APPENDIX B – NOTICE OF MODIFICATION

Notice of Modification

The project approval (08_0101) granted by the Minister for Planning on 26 November 2010 for the Integra Underground Project.

Hebden and Barrett Mine Seam Areas

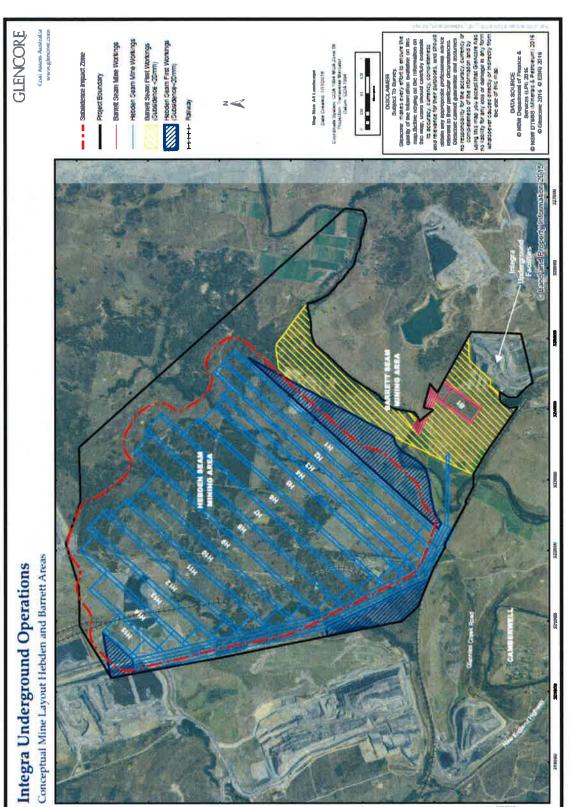
- (b) after the words "in the audit report", insert ", and a timetable for the implementation of any measures proposed to address the recommendations".
- 8. Delete Appendix 3 and replace with the following:
